| FILE NAME = | DESIGNED - JMM | REVISED ADDENDUM A -1/10/11 | | STATE OF ILLINOIS DEPARTMENT OF TRANSPORTATION | WATERMAIN PLAN AND PROFILE IL RTE 56 | | F.A.P. RTE. 365 | SECTION (57 & 58)WRS-2 | COUNTY | TOTAL SHEETS 681 | SHEET NO. 291 | |
| USER NAME = tblank | DRAWN - TMB | REVISED - | | | SCALE: 1"=50' | SHEET NO. 7 OF 11 SHEETS | STA. 333+00 TO STA. 348+00 | CONTRACT NO. 62419 | | ILLINOIS FED. AID PROJECT | | |

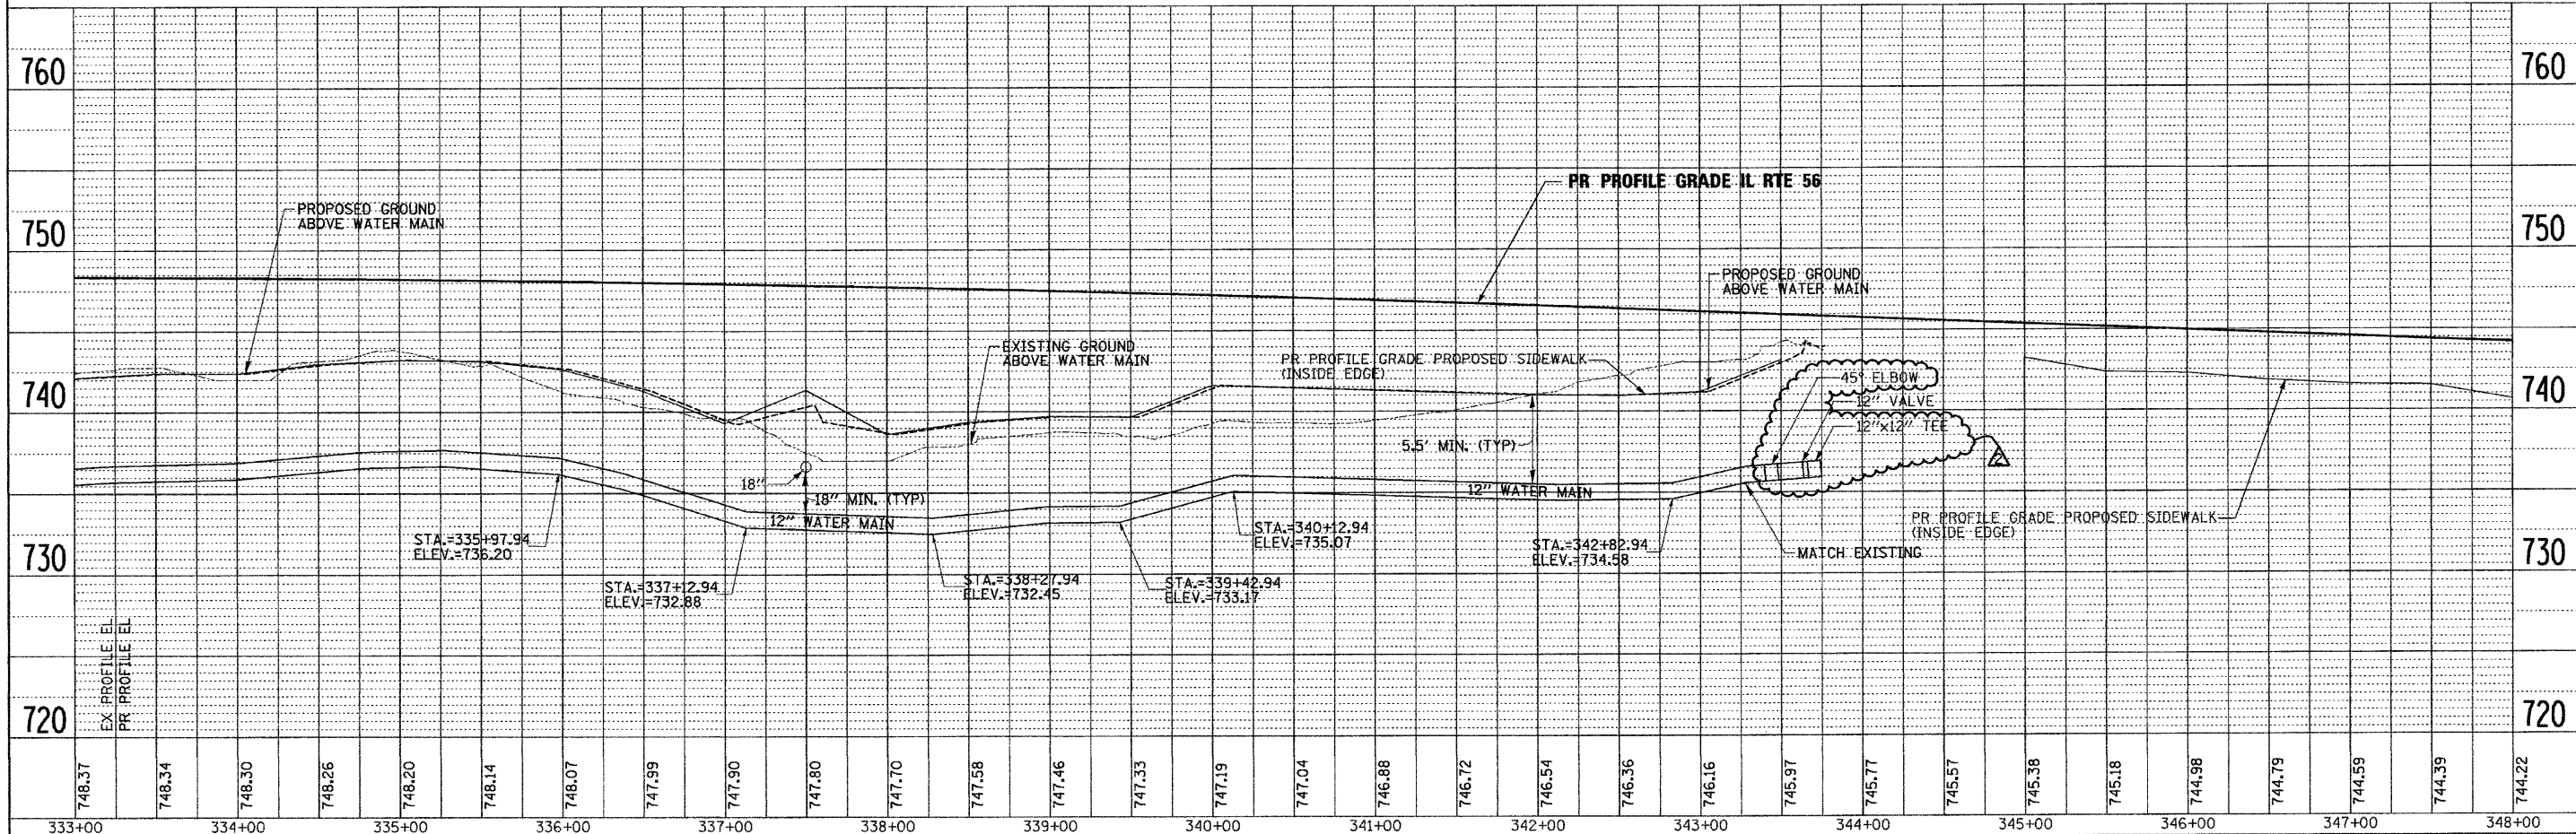
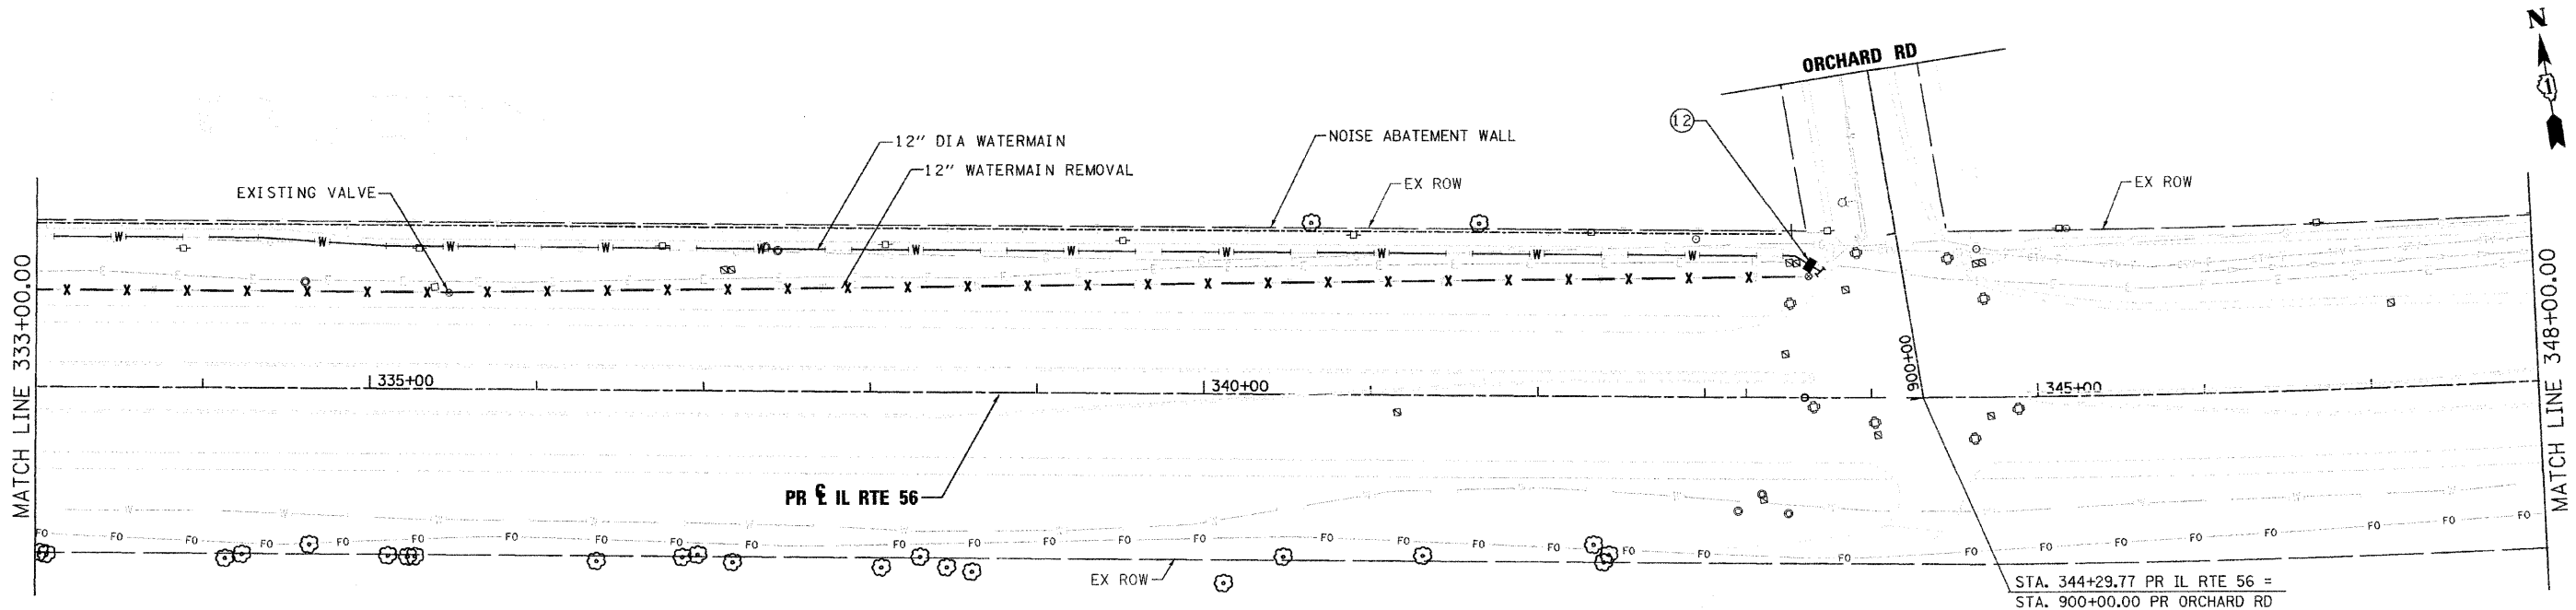
- ⑫ SET: 1-12"x12" TEE AT STA 343+70 (76.00' LT)
- SET: 1-45 DEGREE 12" ELBOW AT STA 343+54 (85.00' LT)
- SET: 1-12" MJ GATE VALVE WITH VALVE BOX AT STA 343+63 (80.00' LT)
- SET: 2" CORPORATION WITH SADDLE FOR CHLORINE ADDITION AND SAMPLE AT STA 343+25 (85.00' LT)
